NUCLEAR REGULATORY COMMISSION

Project WM-10

-Draft Site Characterization Analysis

SUMMARY: The Nuclear Regulatory Commission (NRC) has published a Draft Site Characterization Analysis (DSCA) of the U.S. Department of Energy's Site Characterization Report for the Basalt Waste Isolation Project, a potential high-level waste repository site on the Hanford Reservation in the State of Washington.

Figure 5

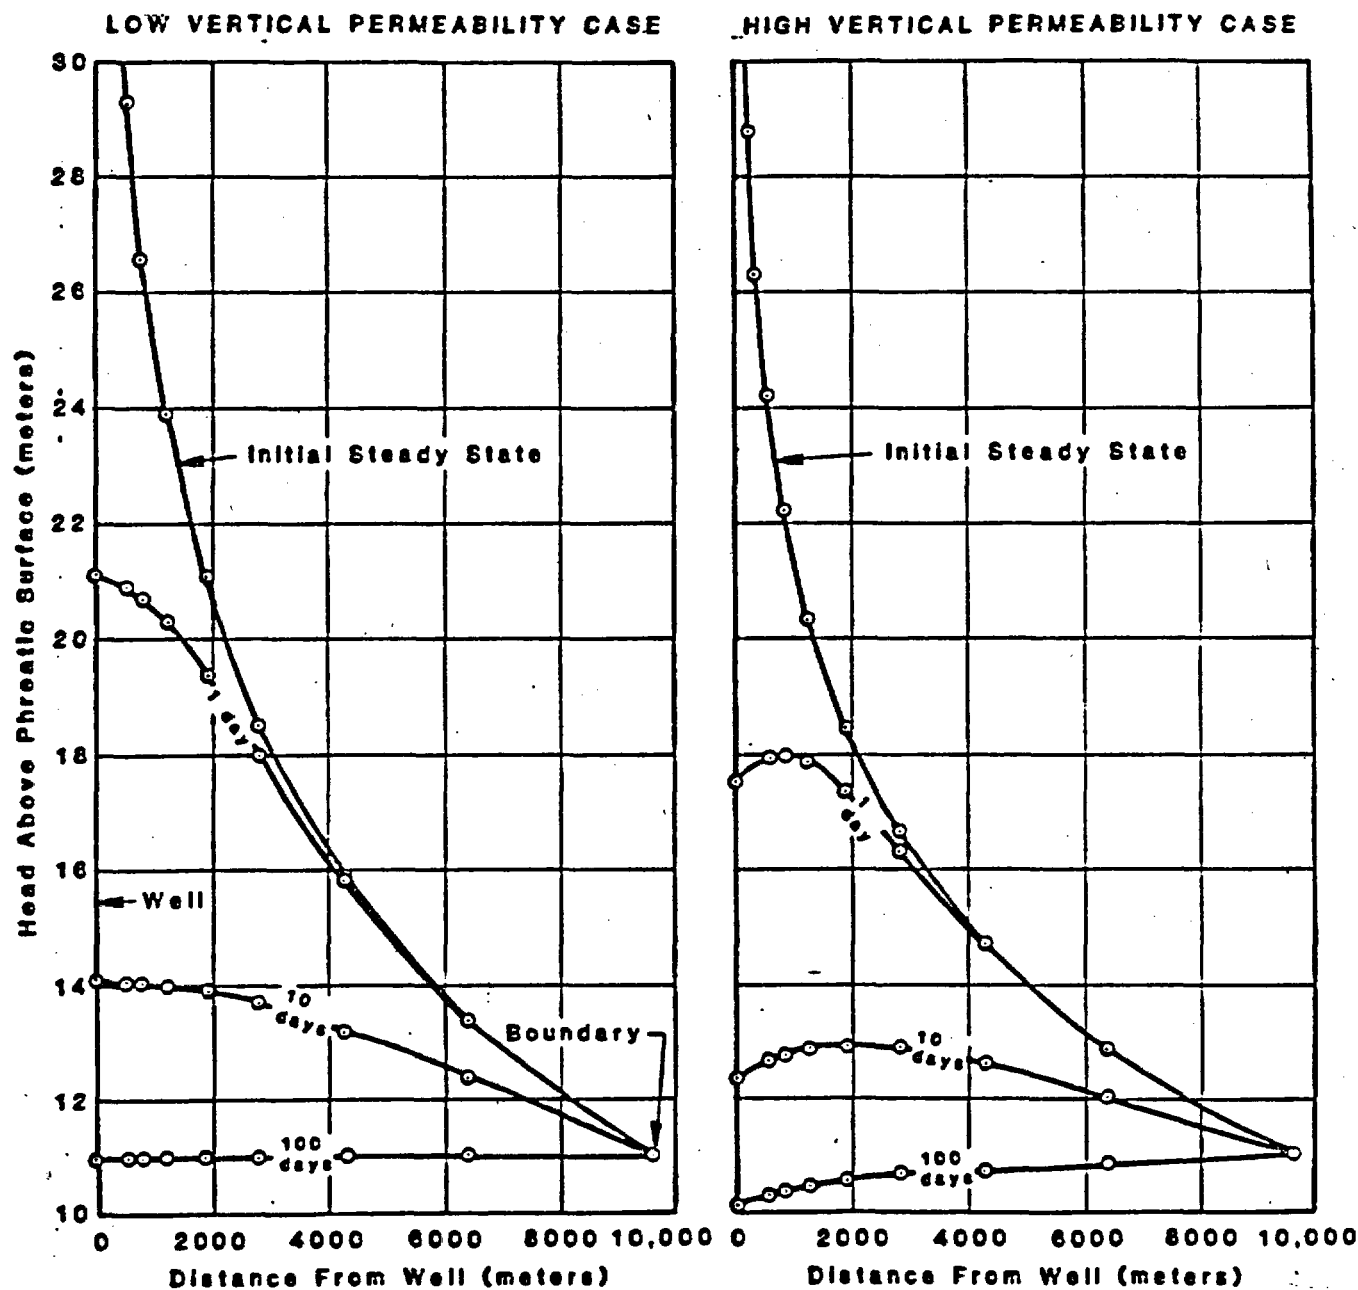
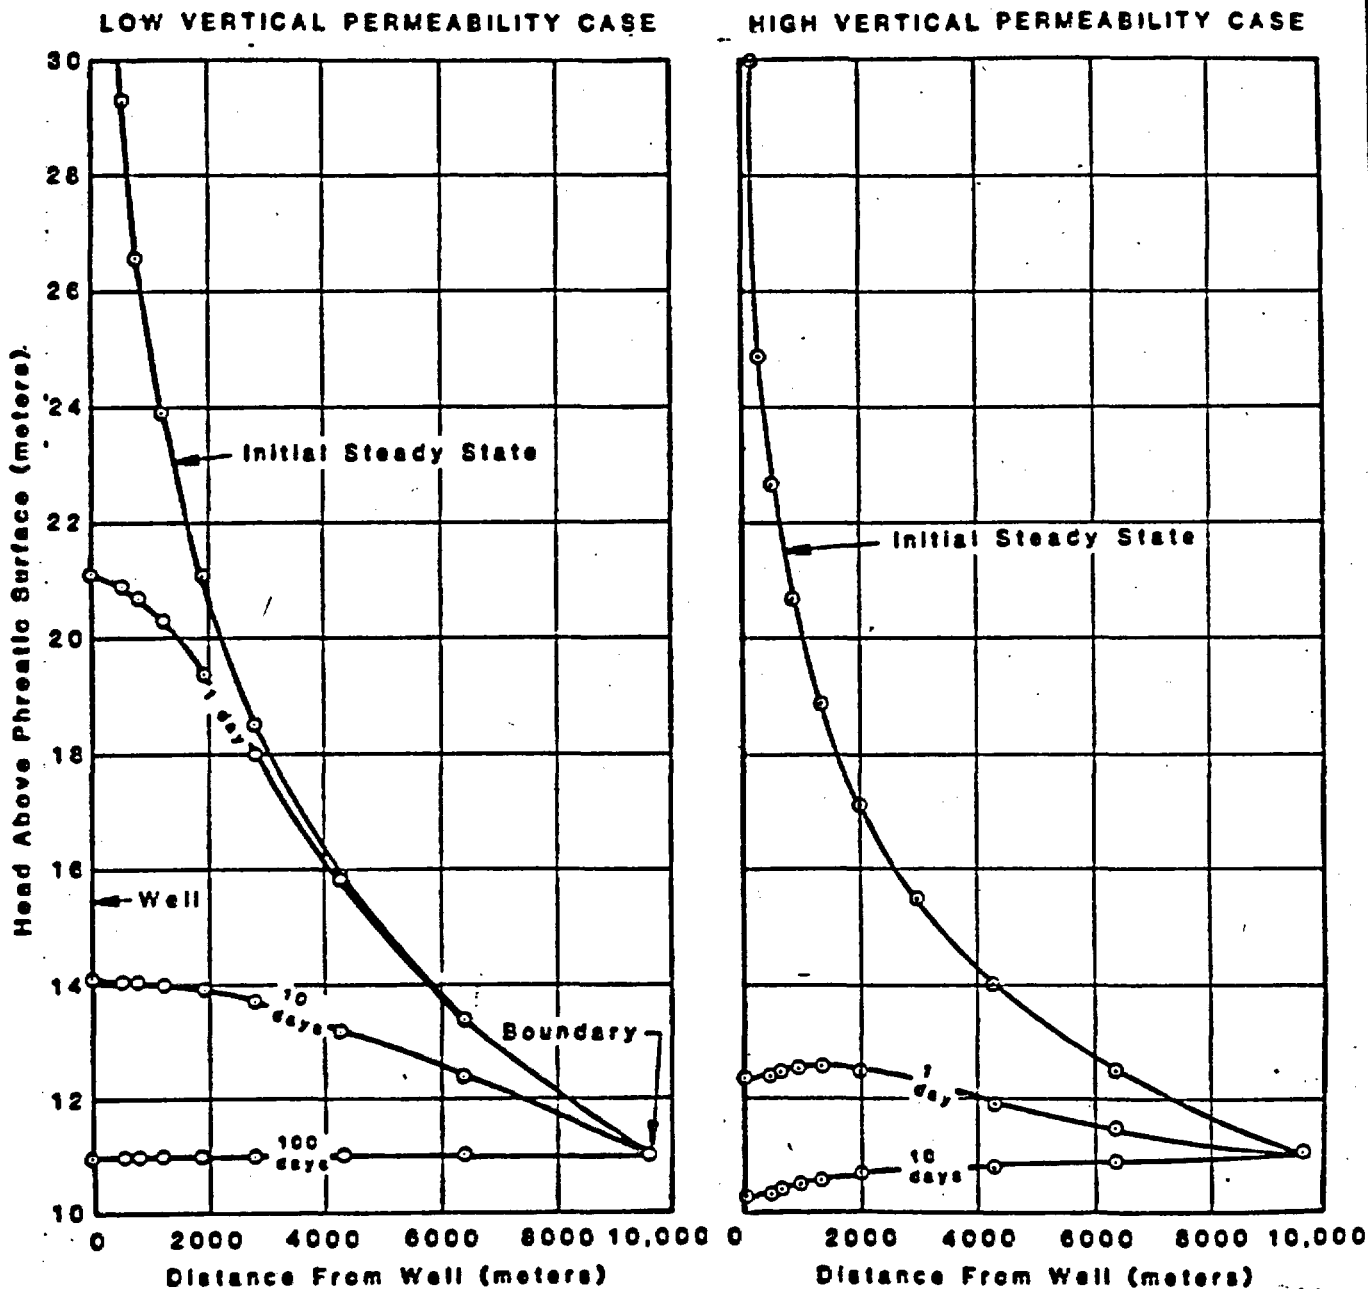
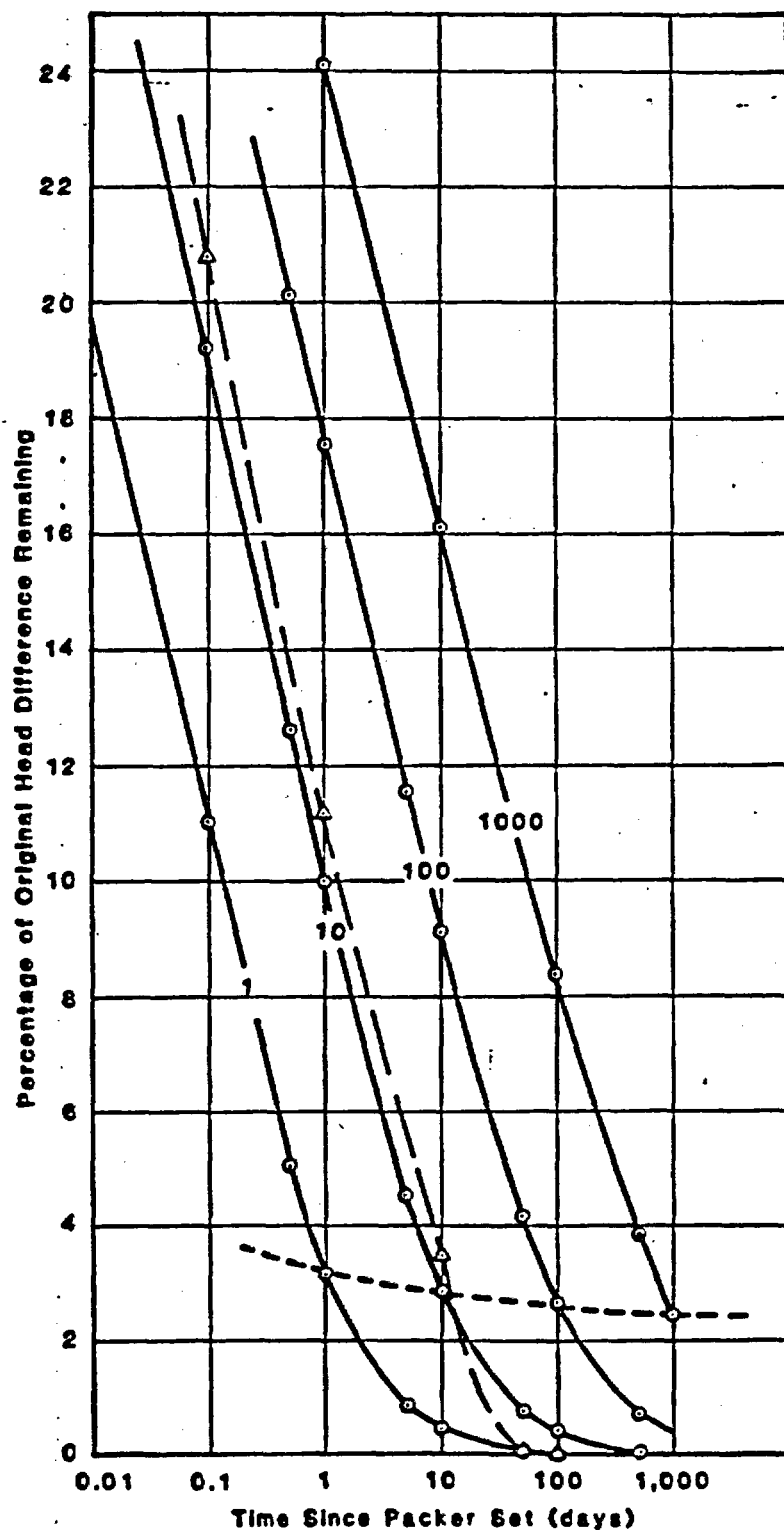
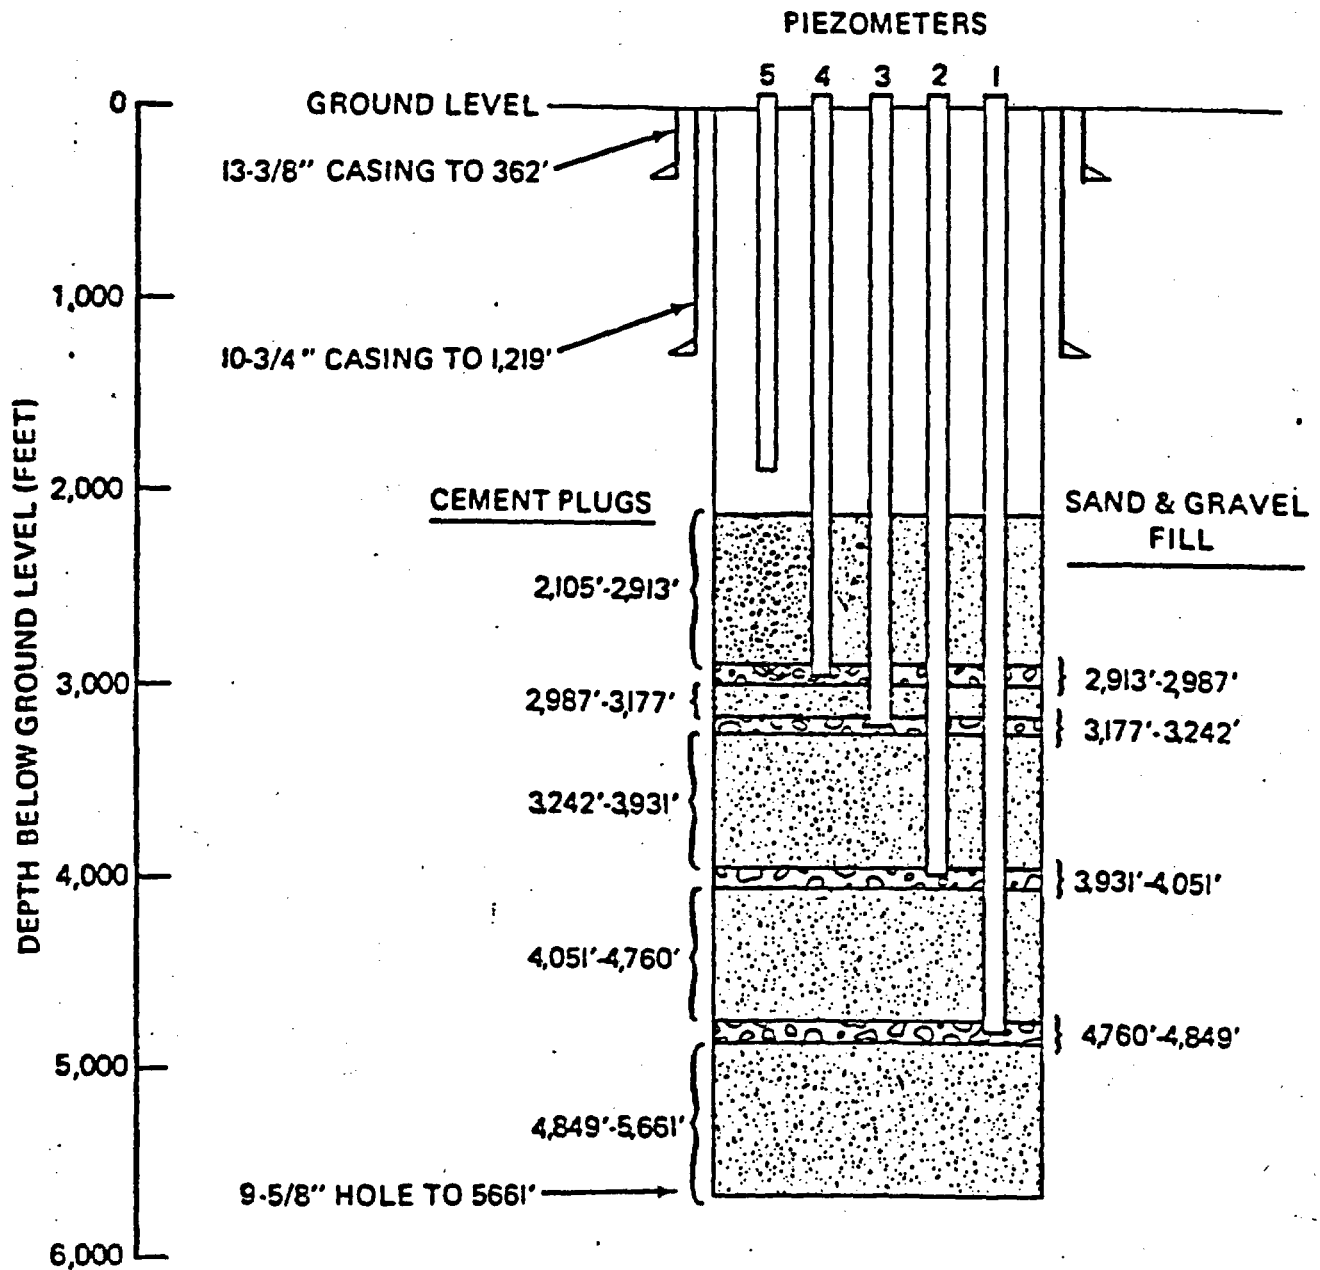
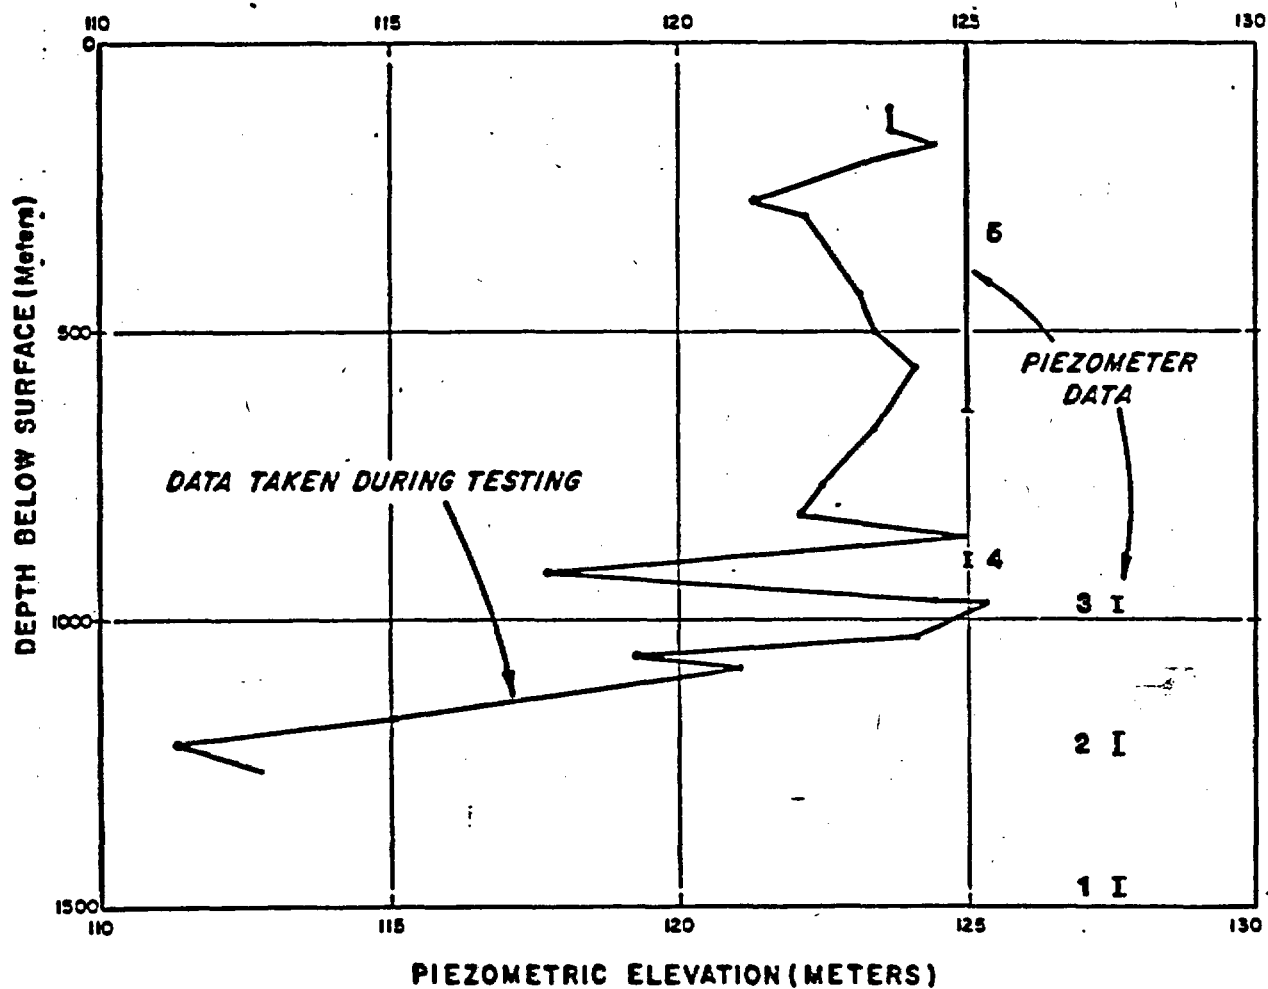
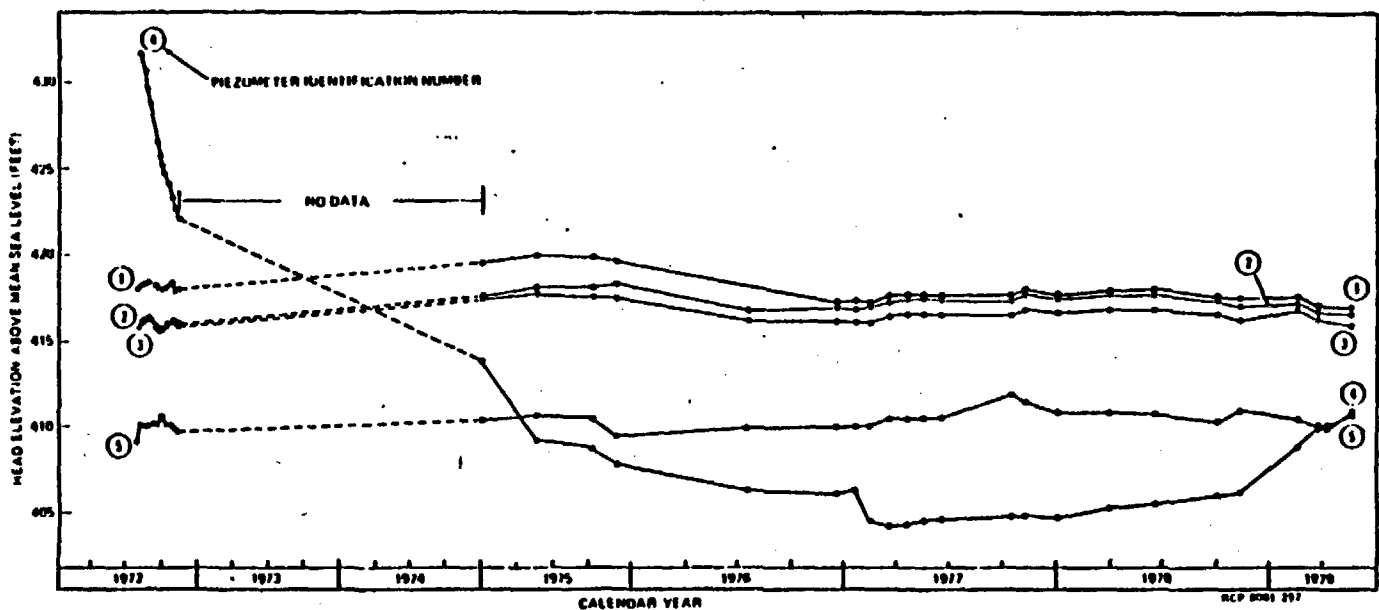
The problems with this method of head measurement are illustrated with two actual case examples where packer testing was used in relatively low permeability, layered rocks (oil shale and basalt). No useful head information was obtained in either case until permanent completions were installed.

There findings are important because they suggest that the present and planned approach to head measurement at Hanford will not produce results which will be useable for the purposes of model calibration or radionuclide transport analyses.
